Access Compliance Report

Public Rights-of-Way

Intersection ID: 14844	Main Street: DILWORTH_RD_WEST	Cross Street: EAST_BV	Location: SW
ADA ID: 642C86161551	Ramp Type: Perp	Initial Pass/Fail: Pass	Overall Compliance: No
			Severity Score: 0.25

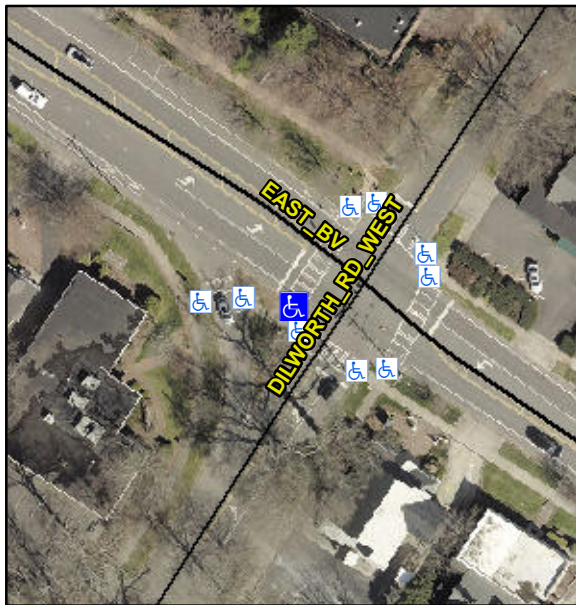
Not Found, R304.5.3

Compliance	Description	Data	Compliance	Description	Data
N/A	Ramp Length (in)	60.0	Yes	Ramp Slope (%)	6.0
Yes	Ramp Width (in)	48.0	No	Ramp XSlope (%)	2.5
N/A	Flare Type LT	Sloped	N/A	Flare Type RT	N/A
N/A	Flare Slope LT (%)	3.5	Yes	Flare Slope RT (%)	3.2
N/A	Flare Traversable LT?	Yes	N/A	Flare Traversable RT?	Yes
Yes	Landing Length (in)	51.0	Yes	DWS Provided?	Yes
Yes	Landing Width (in)	48.0	Yes	DWS Contrast?	Yes
Yes	Landing Slope (%)	0.7	Yes	DWS Length (in)	24.5
Yes	Landing X Slope (%)	2.0	Yes	DWS Full Width?	Yes
N/A	Landing Curb? (Y/N)	No	Yes	DWS Offset (in)	0.0
N/A	Shared Landing?	No			
Yes	Gutter Ponding?	No	Yes	Gutter Slope (%)	3.0
Yes	Gutter Lip Ht (in)	0.0	Yes	Gutter X Slope (%)	1.7
N/A	Painted X Walk1?	Yes	N/A	Painted X Walk2?	N/A
	X Walk 1 Direction	To NE		X Walk 2 Direction	N/A
N/A	X Walk 1 Width (in)	112.0	N/A	X Walk 2 Width (in)	N/A
	X Walk 1 Slope (%)	3.1		X Walk 2 Slope (%)	N/A
	X Walk 1 X Slope (%)	2.0		X Walk 2 X Slope (%)	N/A

Remove & Replace Entire Ramp.
